# 42 HONEYSUCKLE DRIVE COTTAGE CREEK PRECINCT NEWCASTLE

STATE SIGNIFICANT DEVELOPMENT (SSD-10378)  
DEVELOPMENT MODIFICATION 2

ARCHITECTURAL DESIGN STATEMENT

NOVEMBER 2021

# 2.1 DESIGN CHANGES SECOND FLOOR

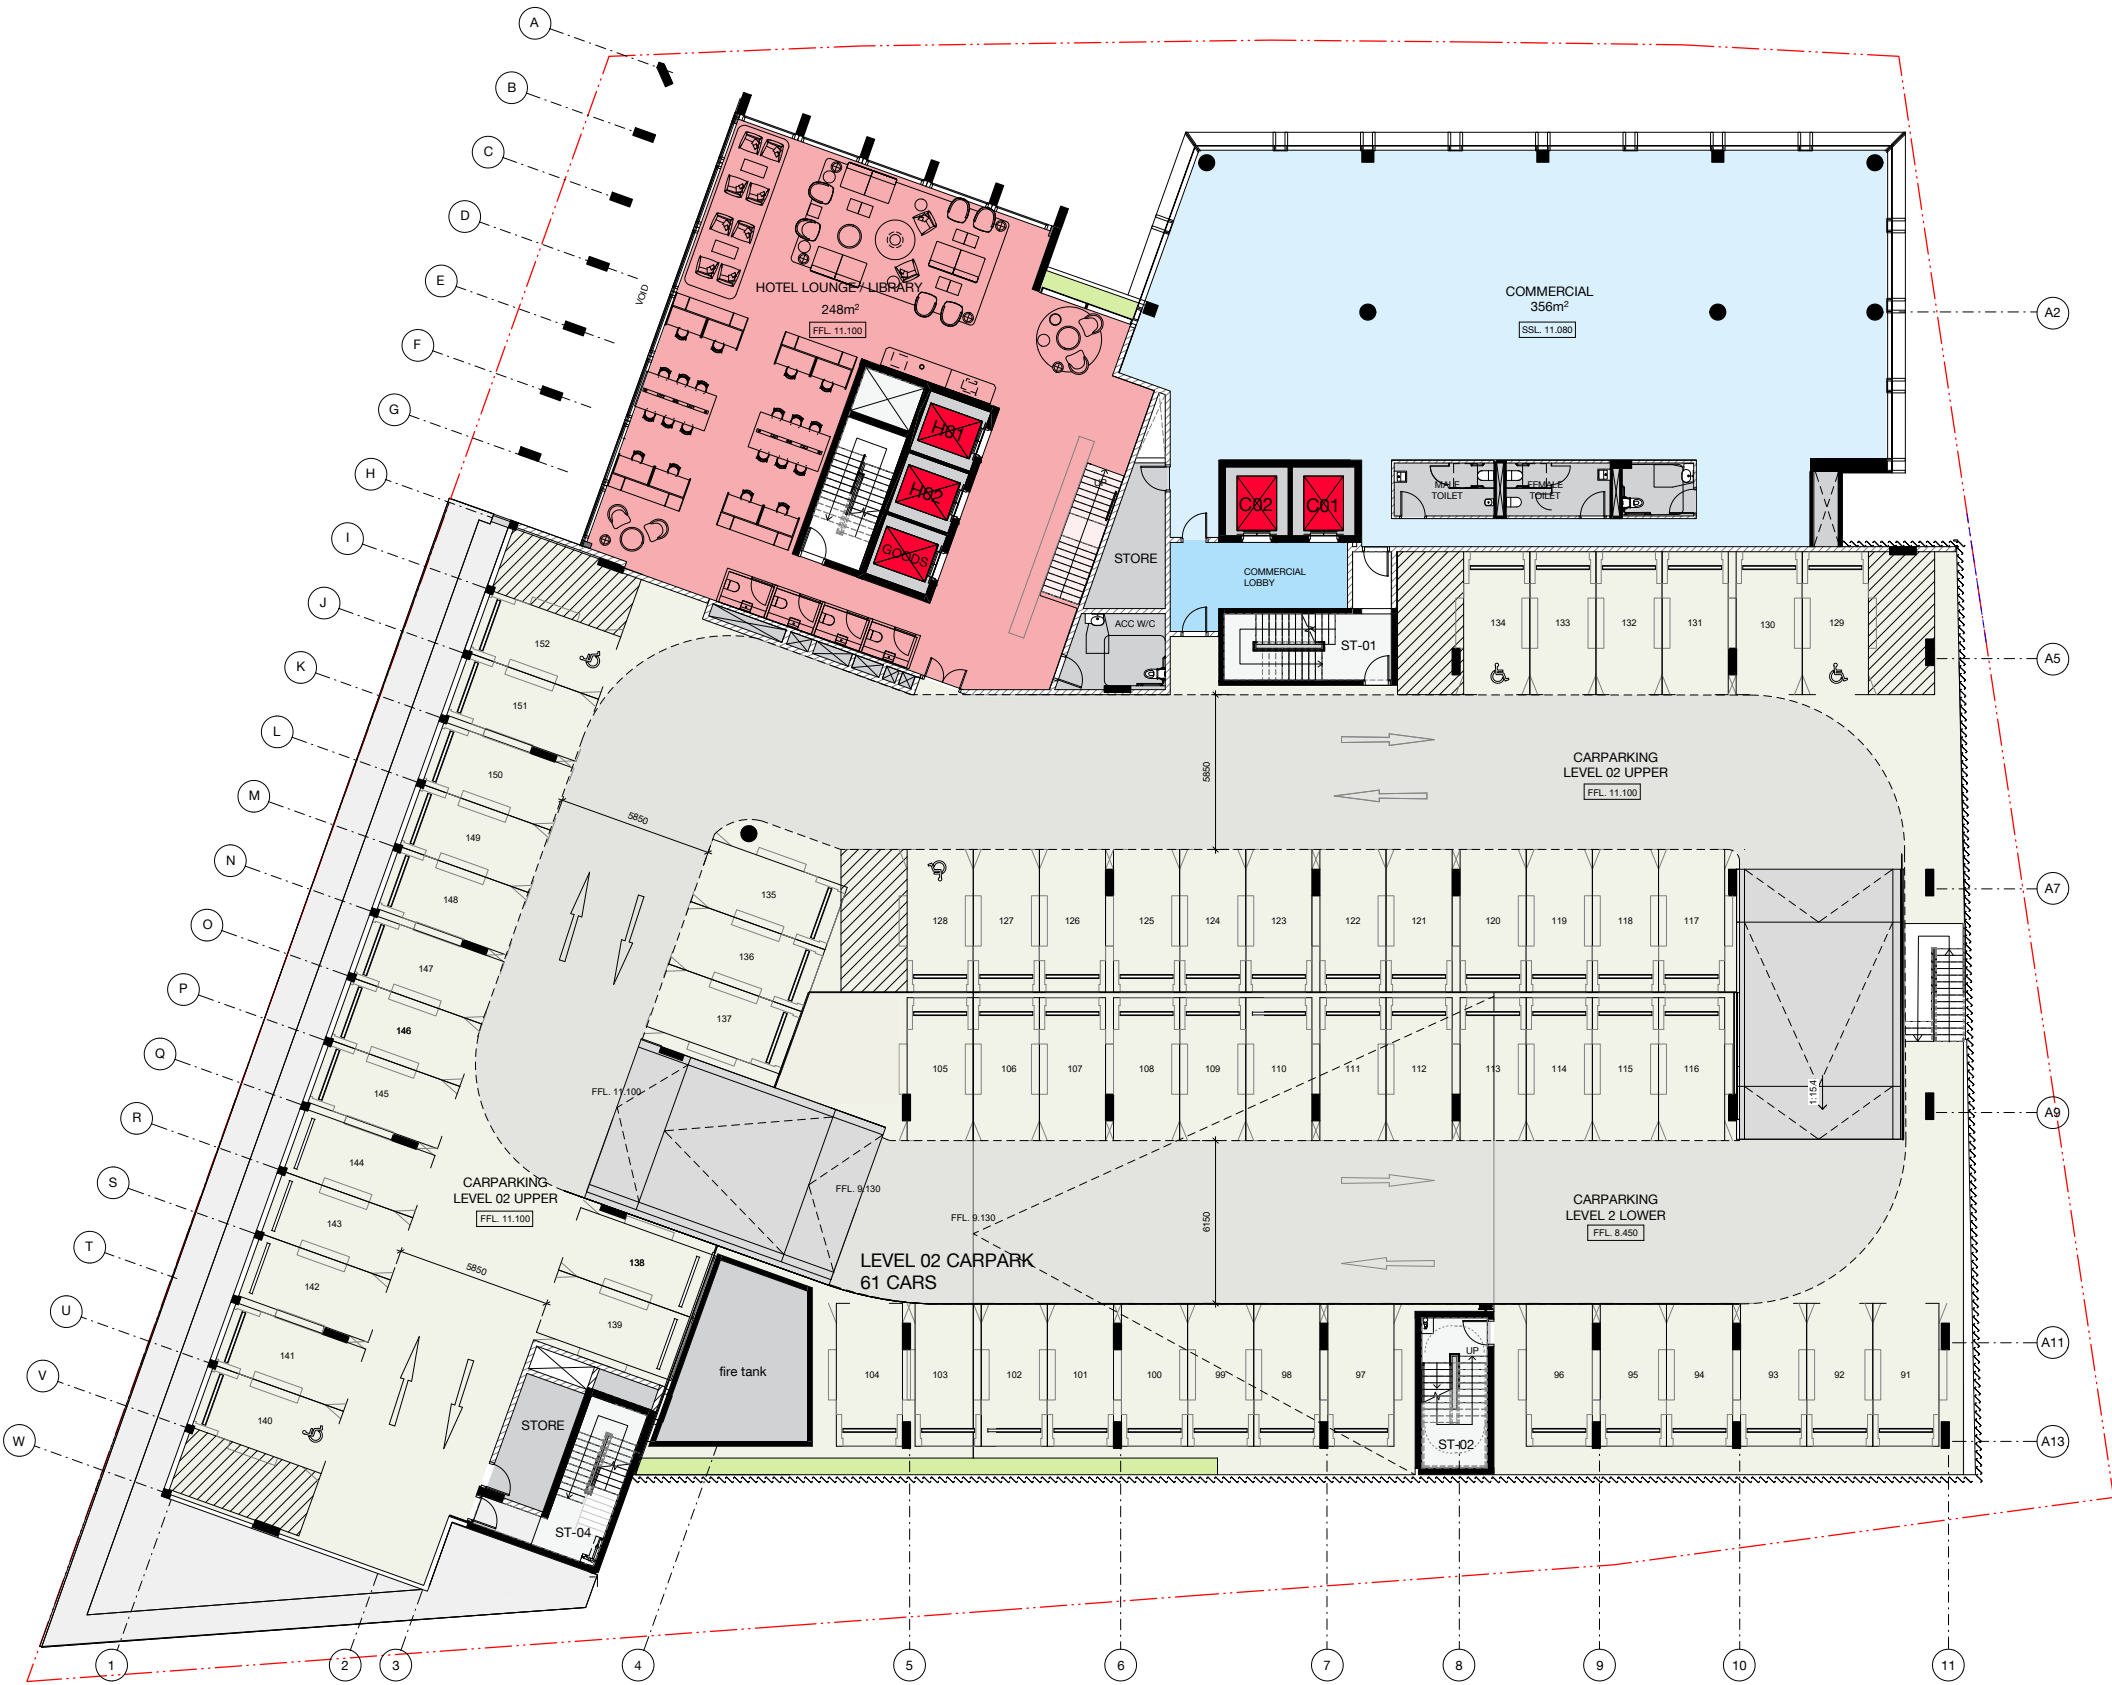
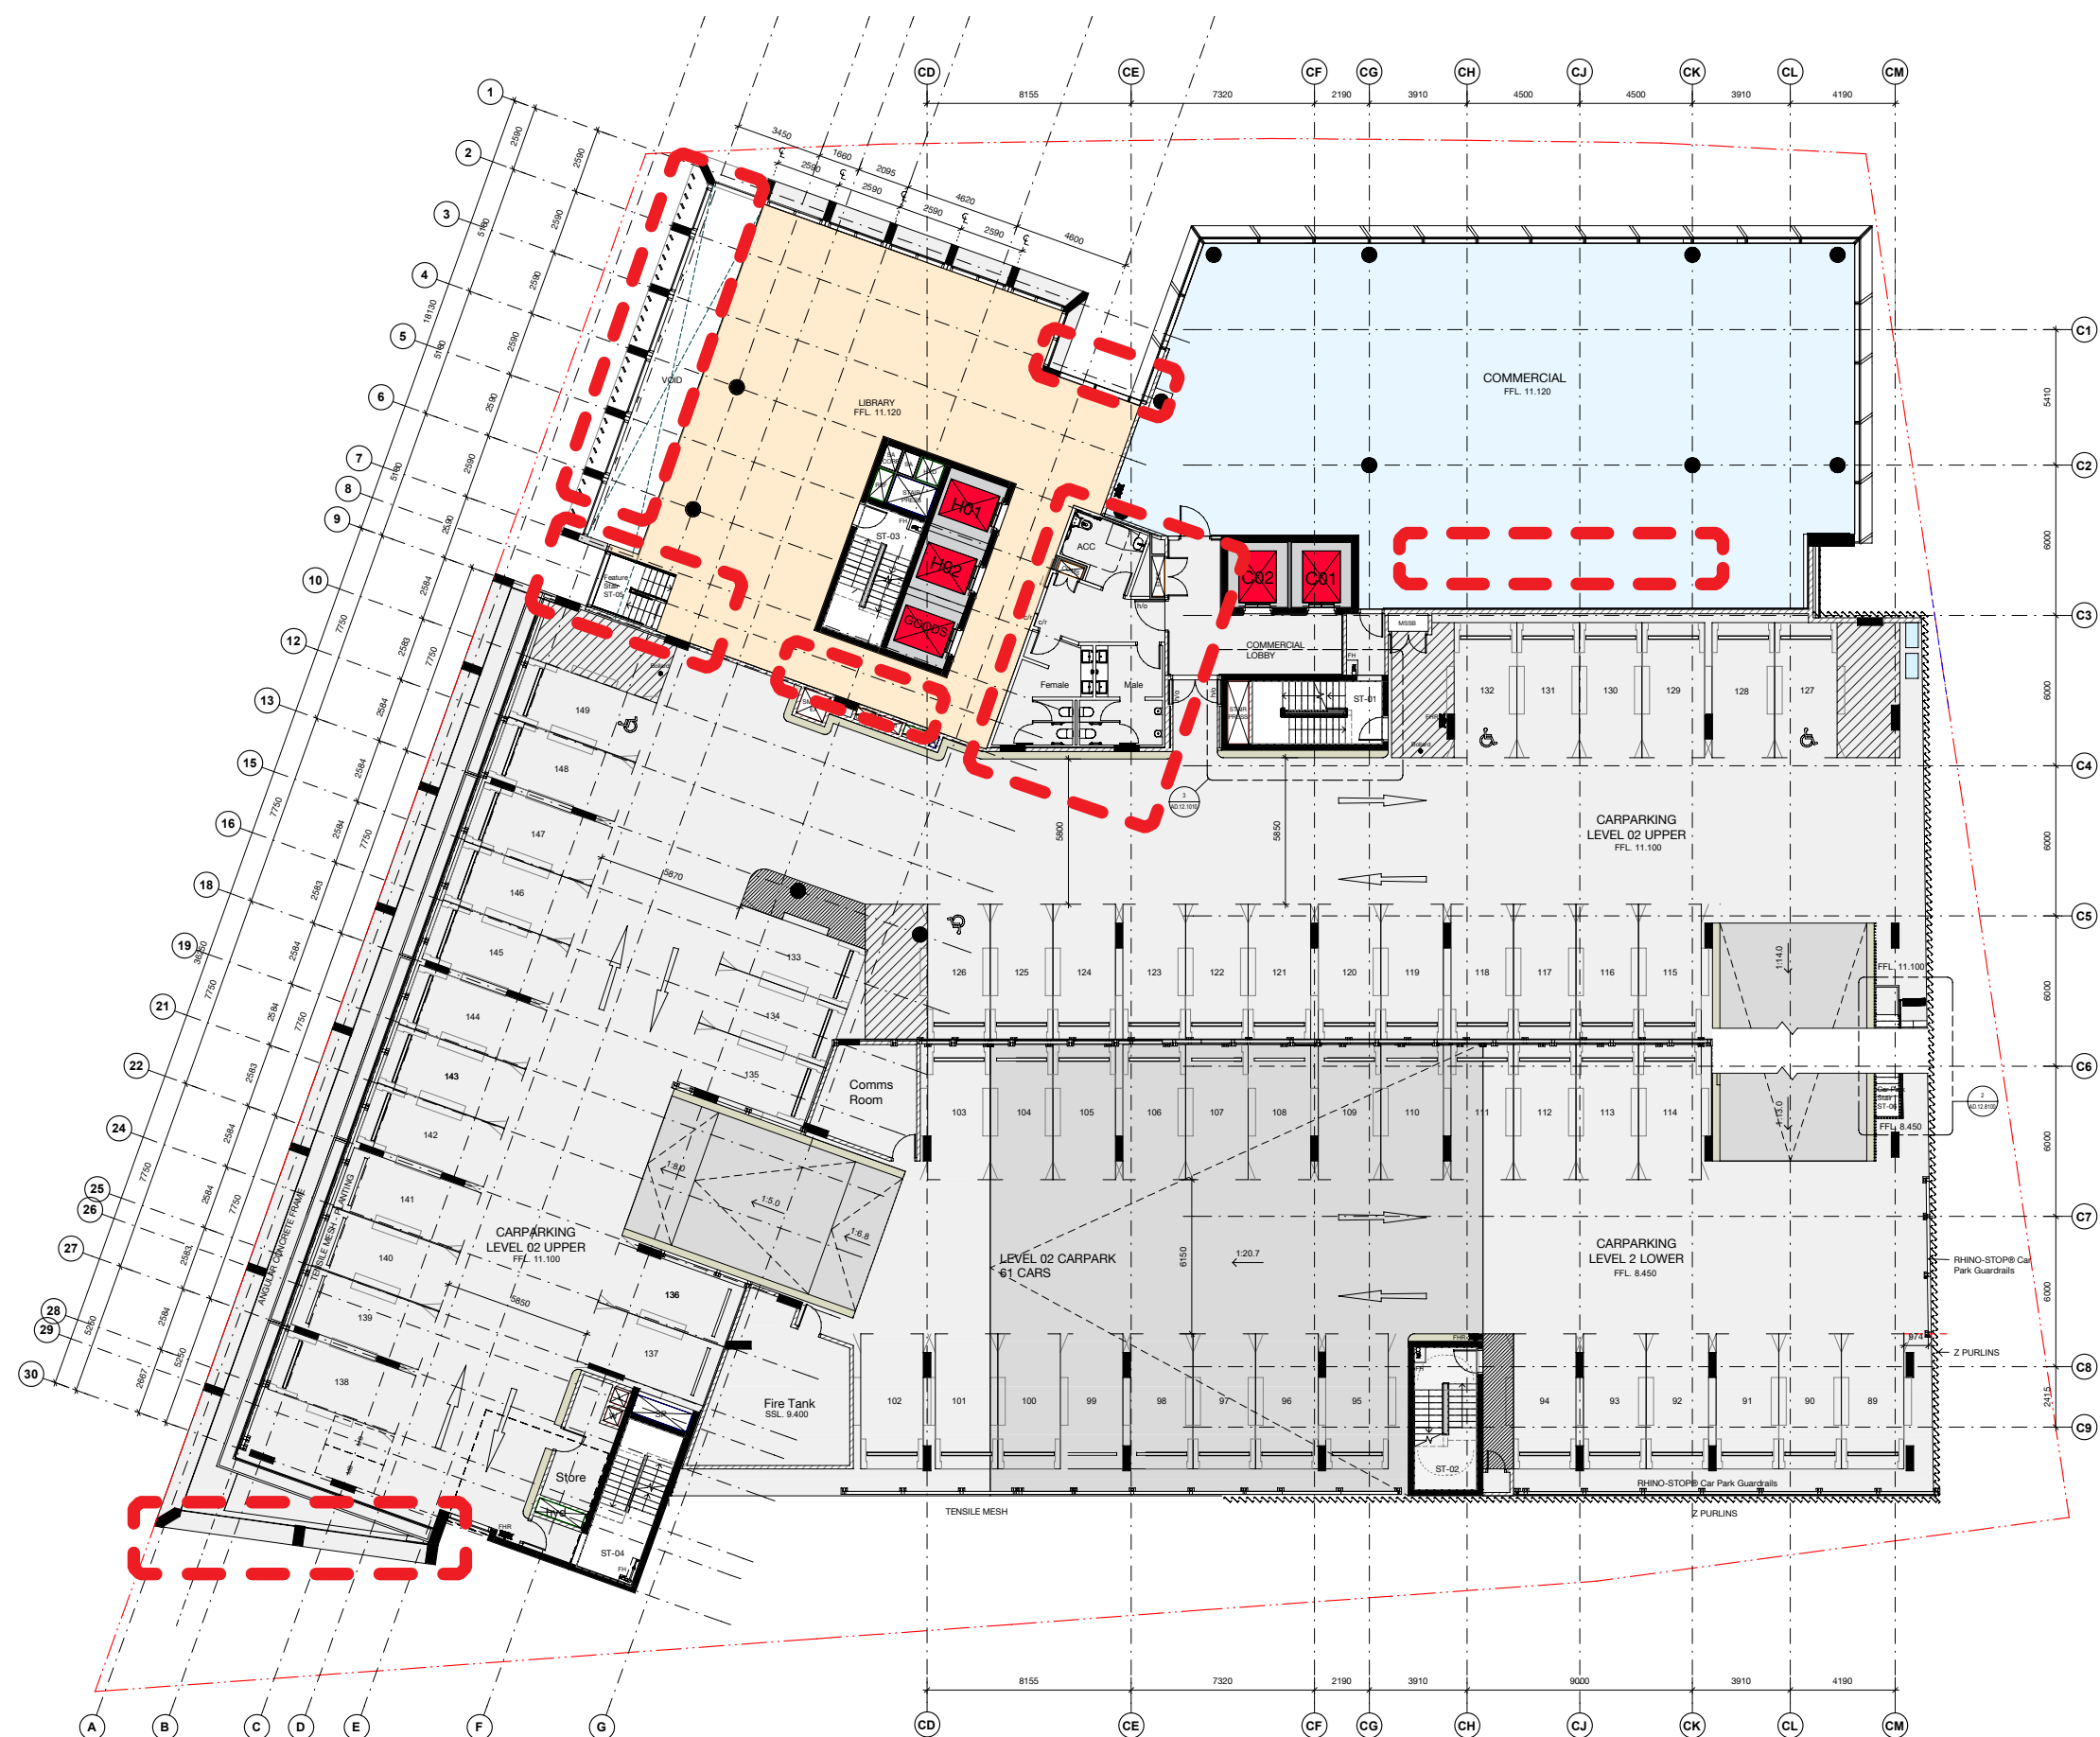
- 1 / South west end of the building at levels L00/L01/L02 set back from south boundary line.
- 2/ Amenities to commercial floor area shifted and combined with the hotel facilities.
- 3 / Feature stair relocated to the western side of the communal space. Stair links from ground floor to level L02.
- 4 / External western terrace off the hotel communal space omitted.
- 5 / Planter between building forms along the Northern elevation at levels L01 and L02 omitted.
- 6 / Loss of 2 parking spaces due to a reduction in the western elevation length
